Re: APPROVAL OF PETITION FROM OLD CHAPEL HILL, LLC. (FORMERLY BISHOP'S HILL, LLC.) – REQUESTING PLANNED DEVELOPMENT DISTRICT ON PARCELS AL-56-2, LOCATED AT 1921 RIVERSIDE DRIVE

Final PDD Review – Staff Comments

Site: 1921 Riverside Drive (Parcel AL-56-2)
Developer: Old Chapel Hill, LLC. (formerly Bishop's Hill, LLC.)
Attn. Keith Garot

REVIEW COMMENTS ON OLD CHAPEL HILL PDD

Staging Plan

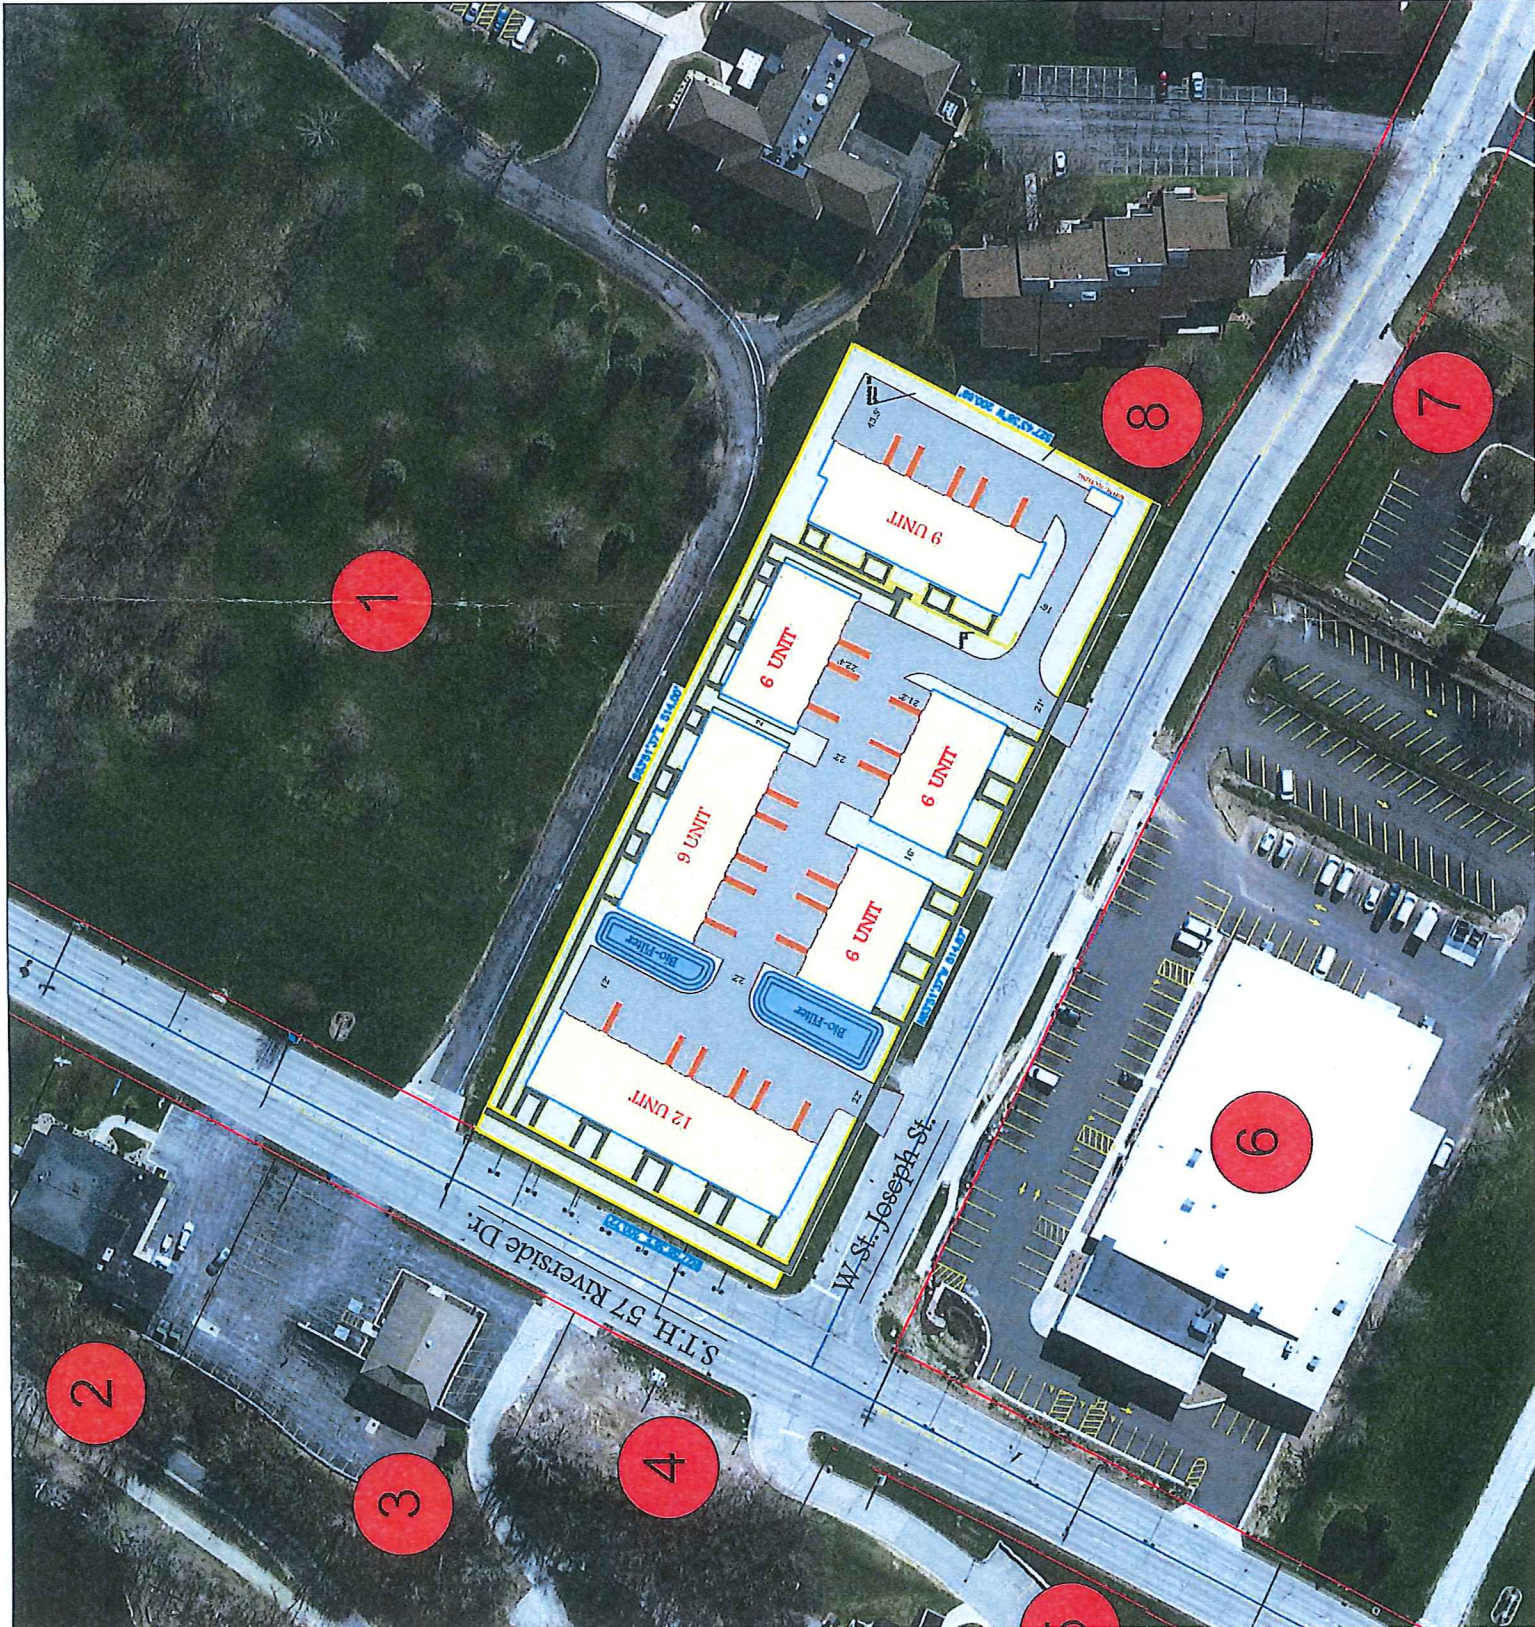
- Final review comments:
 - Detail of the trash enclosure should be provided. The trash enclosure should be screened using the same masonry materials used in primary structures. Additionally, concrete pavement should extend 30 feet out from dumpster to prevent wear from heavy equipment.

Landscape and Lighting Plan

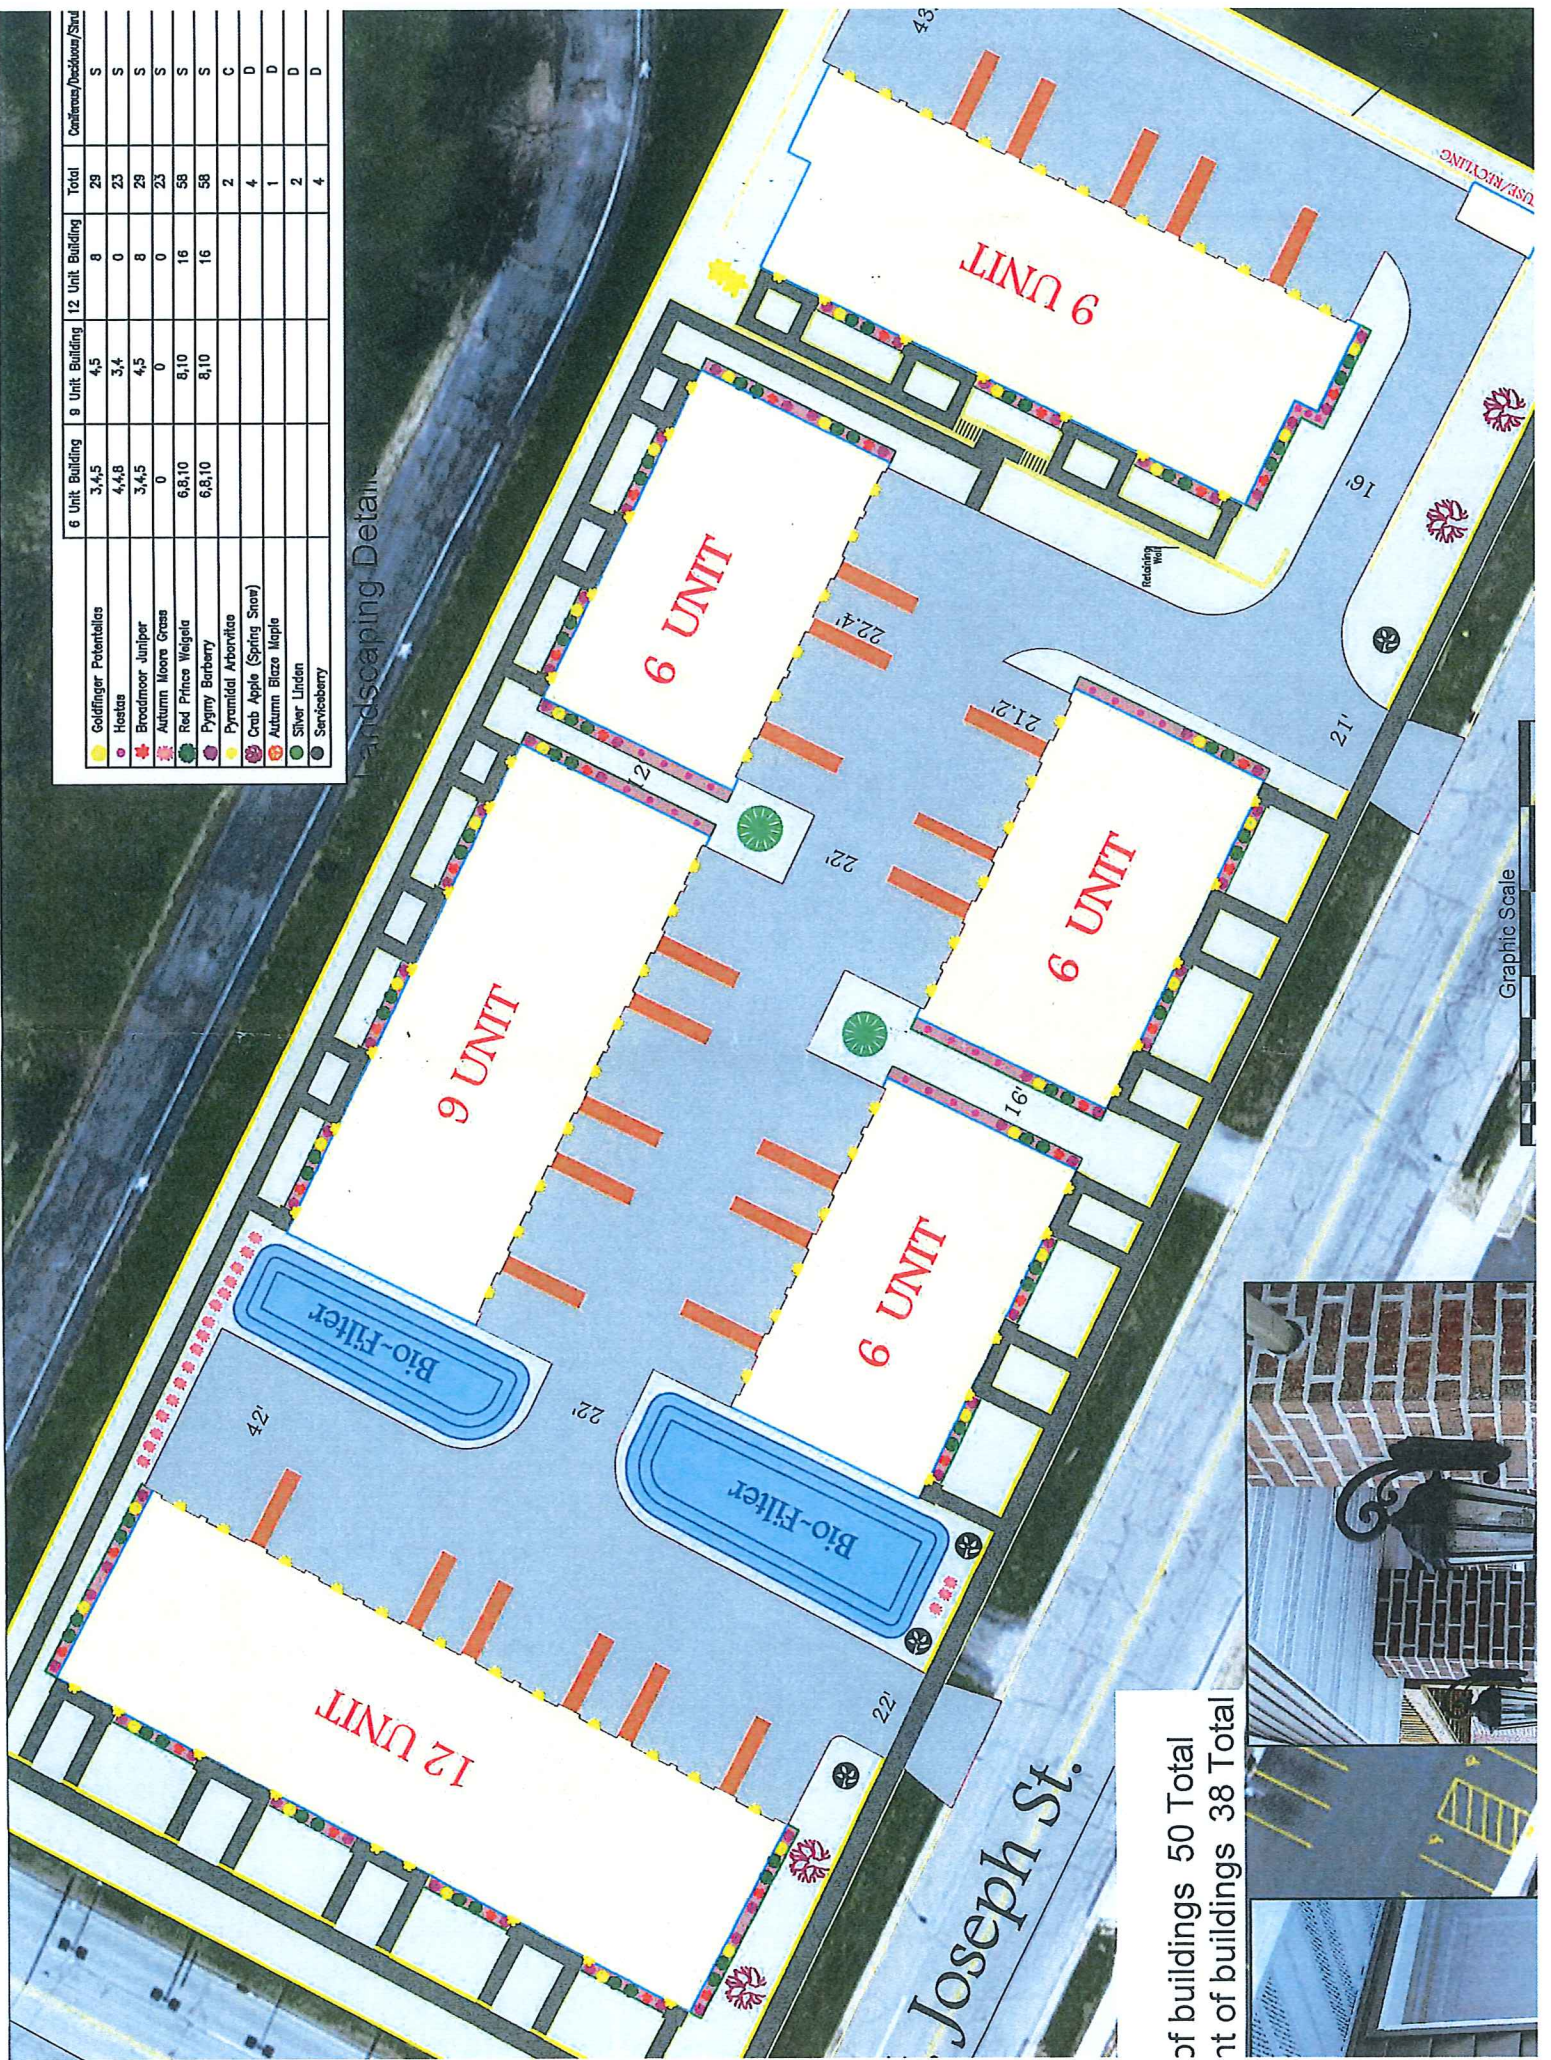
* ADD ENVIRONMENTAL TREES
 ADD SHADE MASS
 Move Hedge Trees
